**PLANNED UNIT DEVELOPMENT  
& SUBDIVISION STAFF REPORT****Date: April 6, 2006****SUBDIVISION NAME**

Fielding Place Subdivision, Lot 5, Revised

East terminus of Fielding Place (private street)

# SITE PLAN

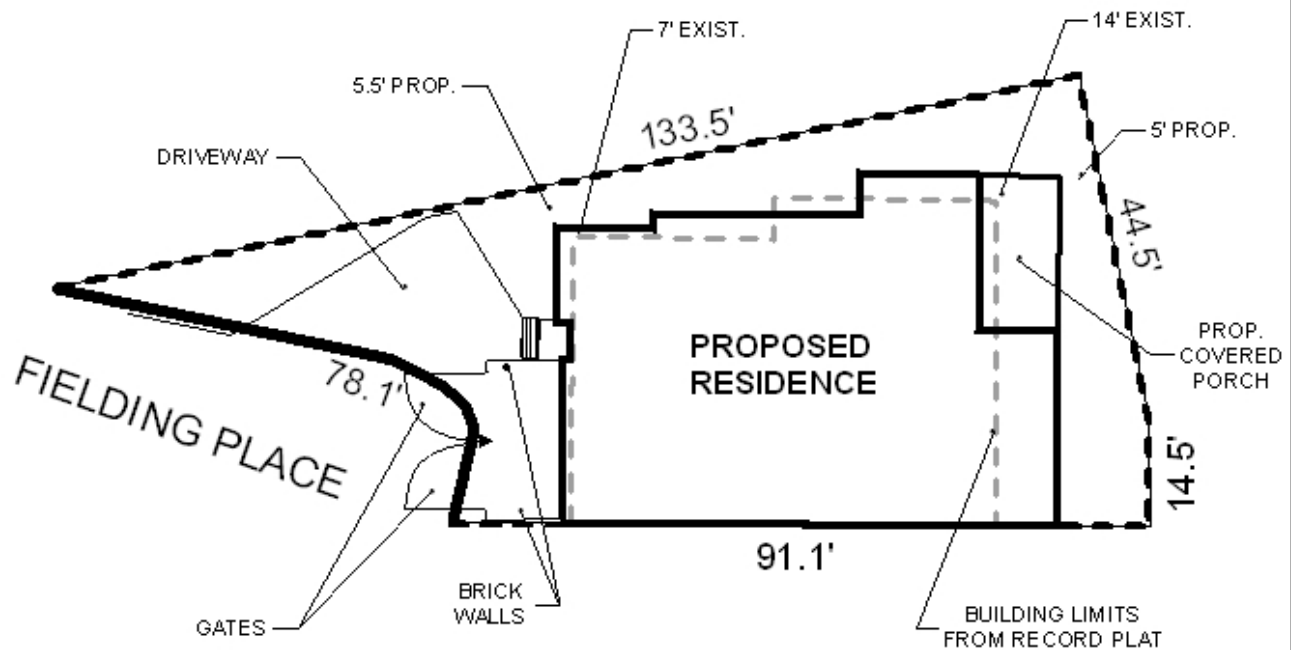
The lot originally received PUD and Subdivision approval as part of Fielding Place in 1984, was recorded, and then apparently re-recorded in 1993; the recorded plat and site plan depicted a polygon labeled “building limits”, which illustrated both the setbacks and the maximum site coverage for each lot. For the subject property, the building limits described a left side setback of nine feet at the closest point; 14 feet at the closest point on the front; ten feet at the closest point on the rear; and a zero-lot line yard on the right side. The maximum site coverage allowed by the record plat is approximately 46%. The applicant is requesting a left side yard setback of 5.5 feet at the closest point; a rear yard setback of five feet at the closest point; and increased site coverage of 56%. The right side yard would remain zero-lot-line. Also, while the applicant is requesting a front setback of 11.5 feet, the site plan shows a wall that would be four feet from the property line, and gates that would open into the street.

Regarding the front setback, there are several examples of 10-foot front setbacks along Fielding Place, but none that are smaller. While the house is consistent with this standard, the brick wall would extend to within four feet of the property line, which would not be acceptable. Of additional concern are the two gates that would swing open into Fielding Place. As PUD review considers circulation, the turnaround of the street should not be obstructed.

Increasing the site coverage would not necessarily be problematic, should detention be shown to be adequate, since other sites in the neighborhood have been allowed similar increases. However, it would not be consistent or appropriate to reduce the left/North setback below the existing seven feet; and the front setback should not be reduced below ten feet, and this figure should include any walls and gates above three feet high.

Based on the preceding, both applications are recommended for denial for the following reasons: 1) the North/left setback should not be reduced below the seven feet currently allowed, due to adjoining property that is outside the PUD; 2) the West/front setback would actually be four feet as proposed, which would not be adequate; 3) it has not been established that there is adequate detention for the increased site coverage; and 4) the gates should not be allowed to open into the street.
